**Bradley Villa, Huddersfield
A641 Bradford Road Site Access Junction and Shepherds
Thorn Lane Ped/Cycle Access**

Response Report to Road Safety Audit Stage 1

July 2022 (Final)

Appendix C Optima drawing 19154/GA/01 Revision H

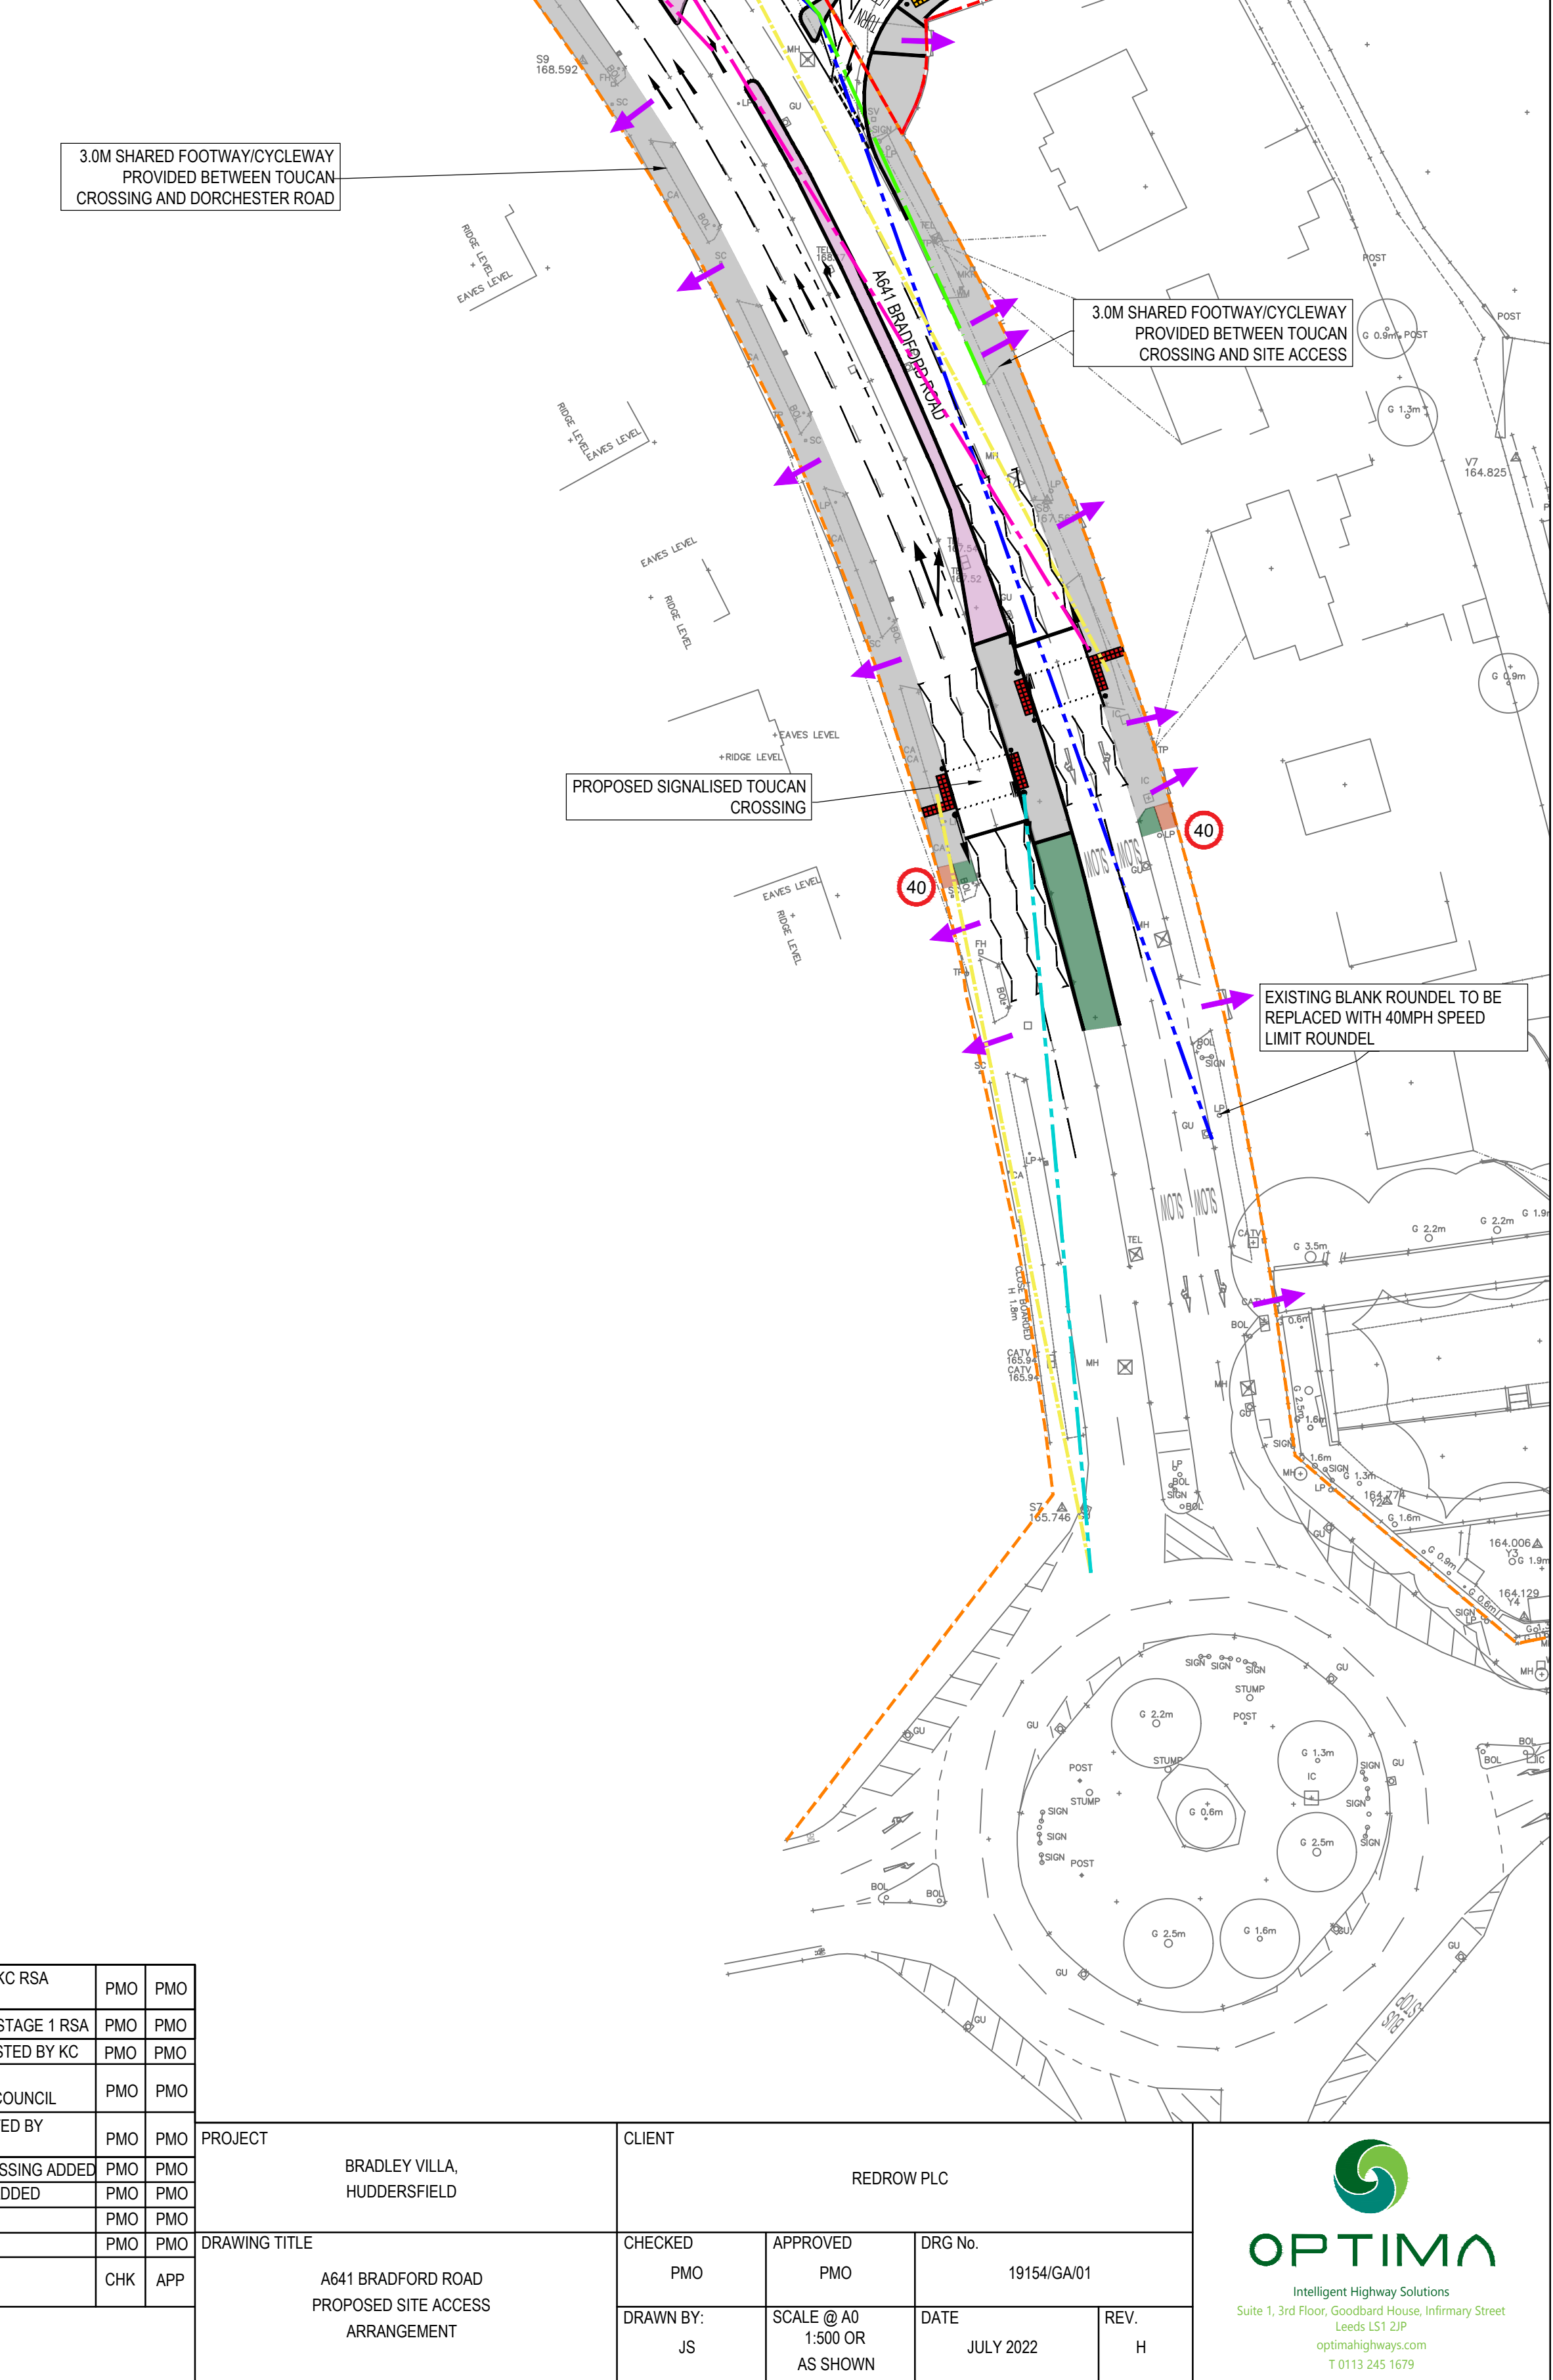
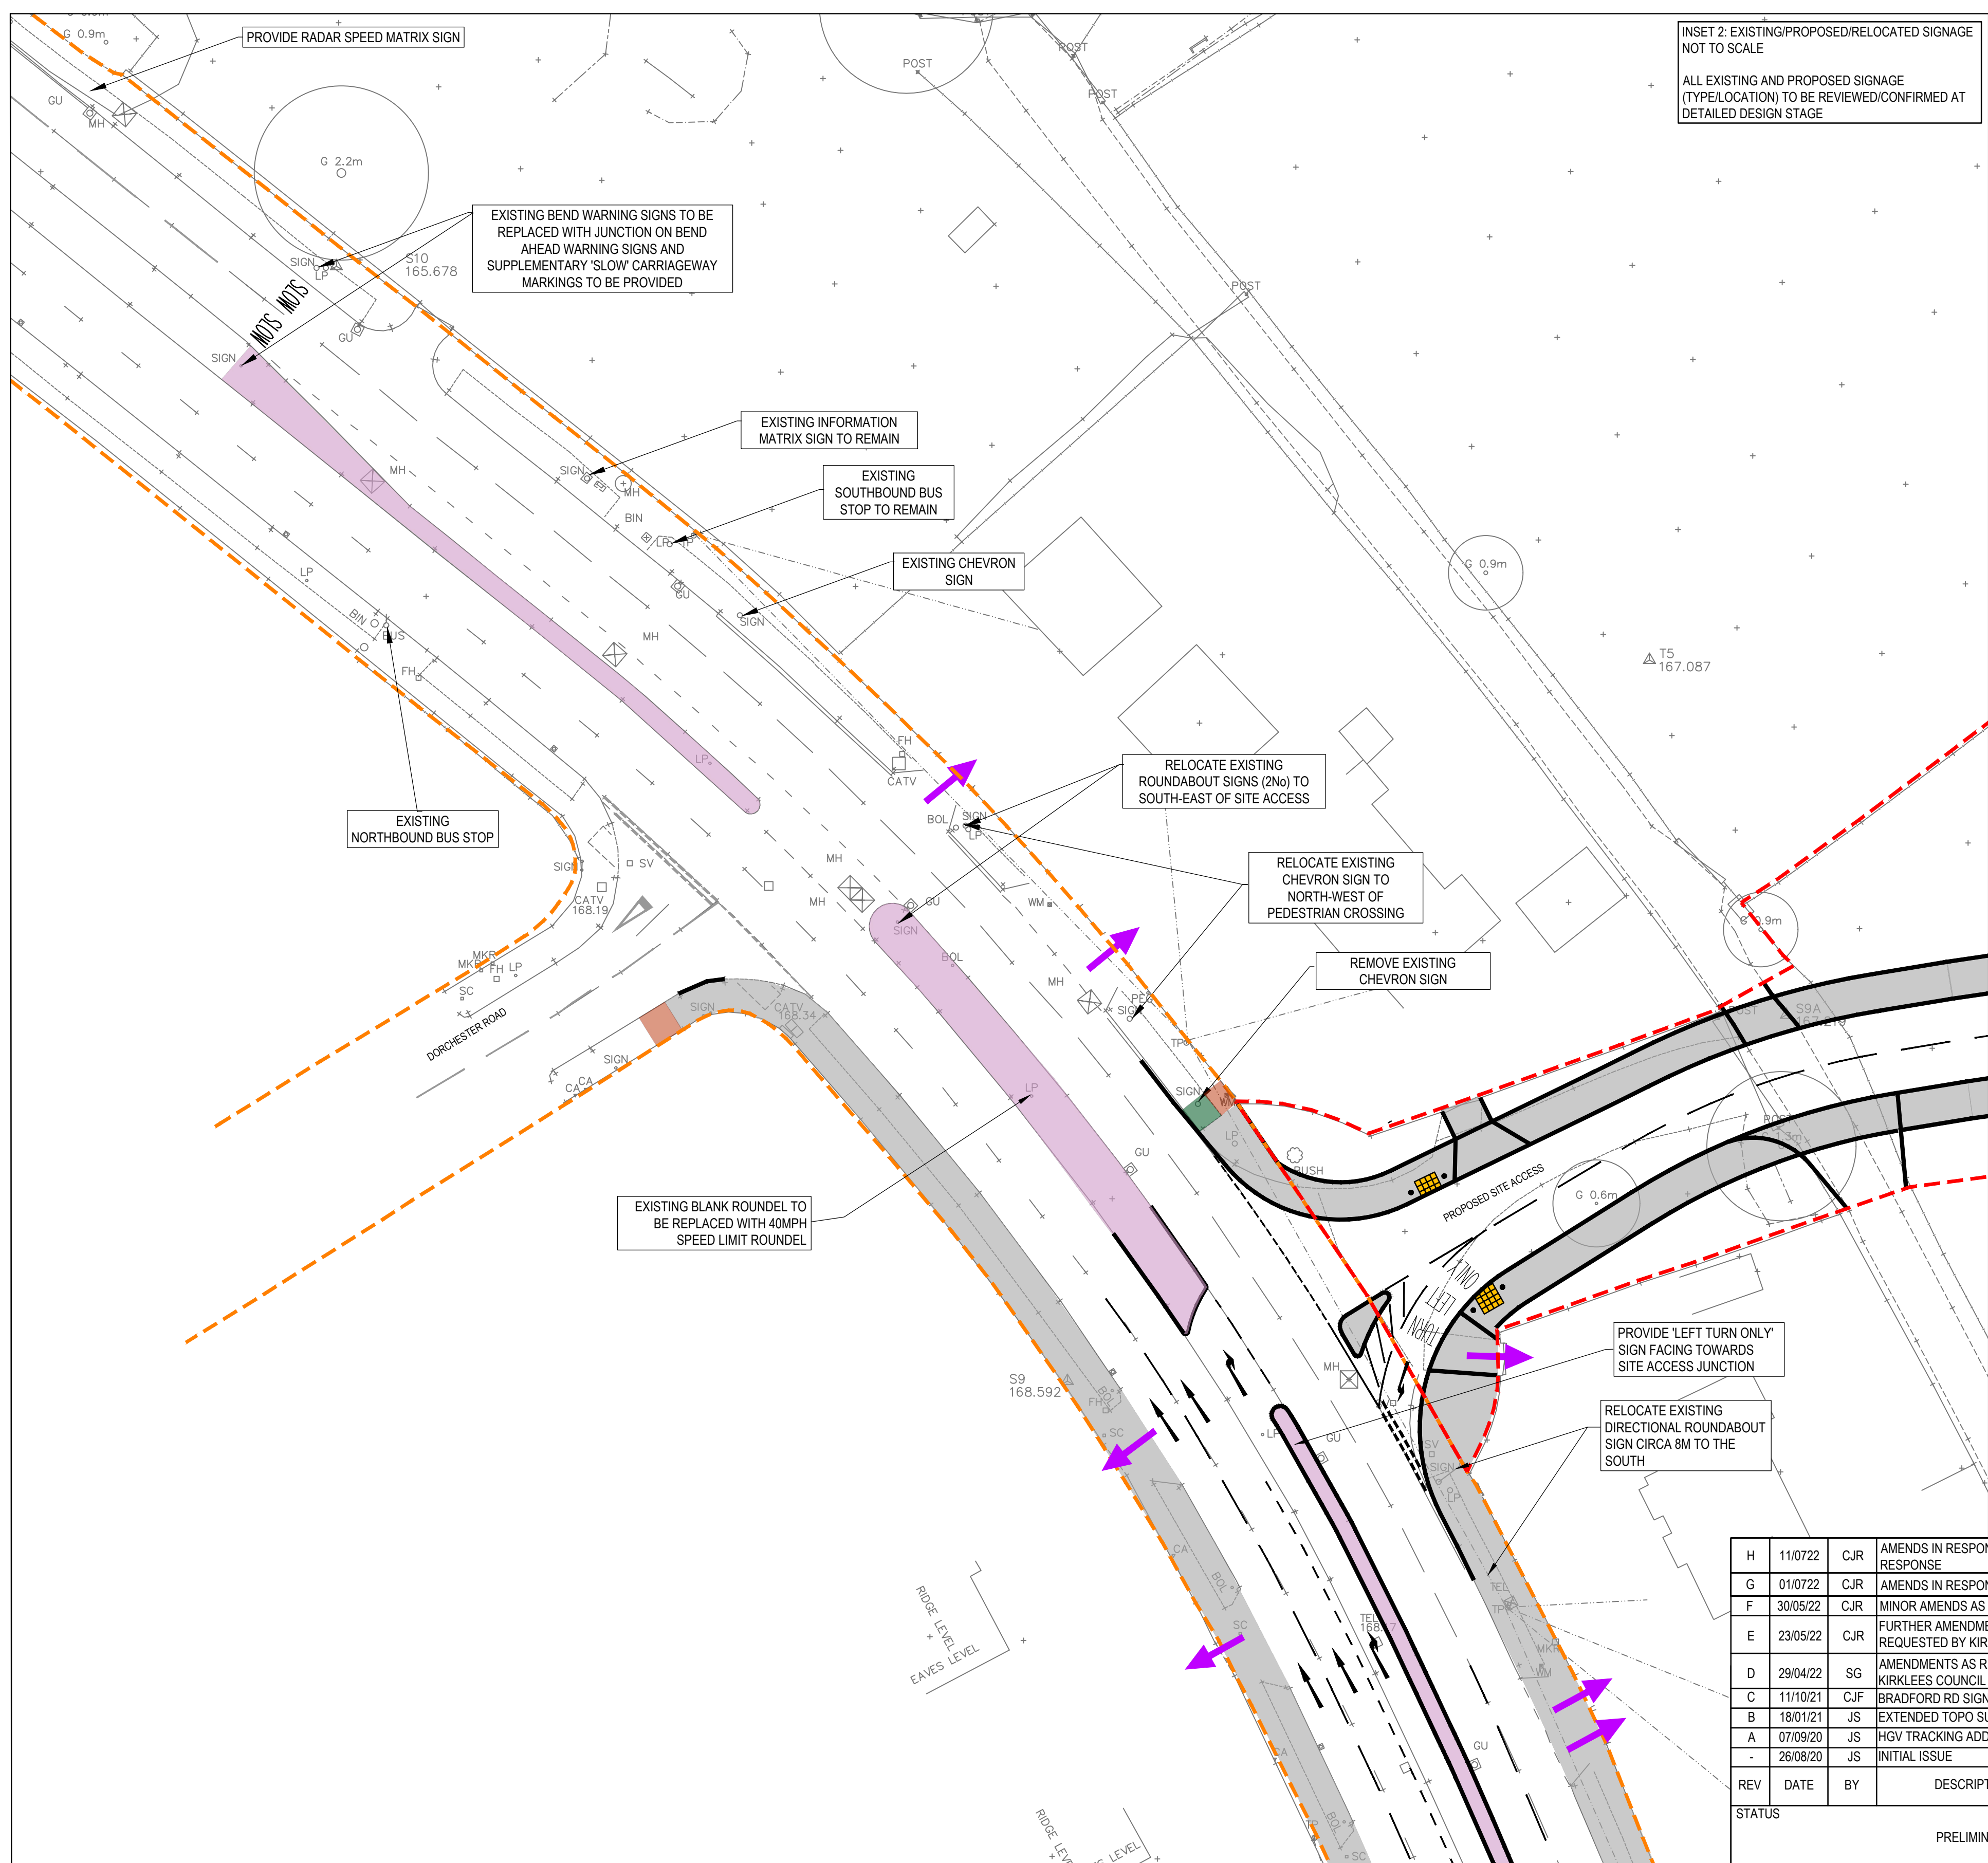
3.1.1 Problem: Central Island at priority junction may encourage right turns

The proposed drawing shows the give-way central island and central reserve along A641 Bradford Road. The arrangement may encourage (and physically still allow) drivers exiting the site to illegally turn right through the adjacent right-turn lane in order to avoid having to route southbound towards the Bradley Bar Roundabout and back north again. This will result in vehicle conflict and collisions.

It is recommended that the designs of the proposed site access junction give-way central island and A641 Bradley Road central reservation are amended to make the aforementioned dangerous manoeuvre as difficult as possible.

RSA Problem	RSA Recommendation	Design Organisation Response	Overseeing Organisation Response	Agreed RSA Action
3.1.1 Problem: Central Island at priority junction may encourage right turns Location – Centre of proposed site access / A641 priority junction. Summary – Proposed arrangement of give-way central island and central reservation may encourage vehicles to turn right through the right-turn lane. Detail – The proposed drawing shows the give-way central island and central reserve along A641 Bradford Road. The arrangement may encourage (and physically still allow) drivers exiting the site to illegally turn right through the adjacent right-turn lane in order to avoid having to route southbound towards the Bradley Bar Roundabout and back north again. This will result in vehicle conflict and collisions.	It is recommended that the designs of the proposed site access junction give-way central island and A641 Bradley Road central reservation are amended to make the aforementioned dangerous manoeuvre as difficult as possible.	The RSA recommendation is noted, and amendments have been made to the central reserve as shown on the drawing attached at Appendix C. The vehicle tracking drawing contained at Appendix E has also been updated to reflect the changes made.	The original layout already discourages right turn movements from the site access, through the provision of a deflection island on the minor arm, an extended central island adjacent to the right turn lane and the provision of the left turn only sign. Whilst the suggested extension of the central island would further discourage right turns from the site access, it also restricts the right turn movement into the access, which would be extremely constrained for large vehicles and this could result in overrunning of the islands. Therefore, the suggested alteration is not accepted. Due to vehicle swept path requirements on the minor arm, it does not appear possible to increase the size of the deflection island further as an alternative option. Therefore, it is instead suggested that additional left turn only text and arrow road markings are provided on the site access exit to reinforce the turning restriction at the junction.	Alterations to the design to make the right turn out of the Site access 'as difficult as possible' is not accepted. The layout already discourages right turning traffic out of the Site access and any extensions to kerb lines would be problematic for large vehicles manoeuvring into and out of the Site access. The agreed action is to provide additional left turn only text and arrow markings on the Site access to reinforce the turning restriction at the junction – as shown on the drawing attached at Appendix C.
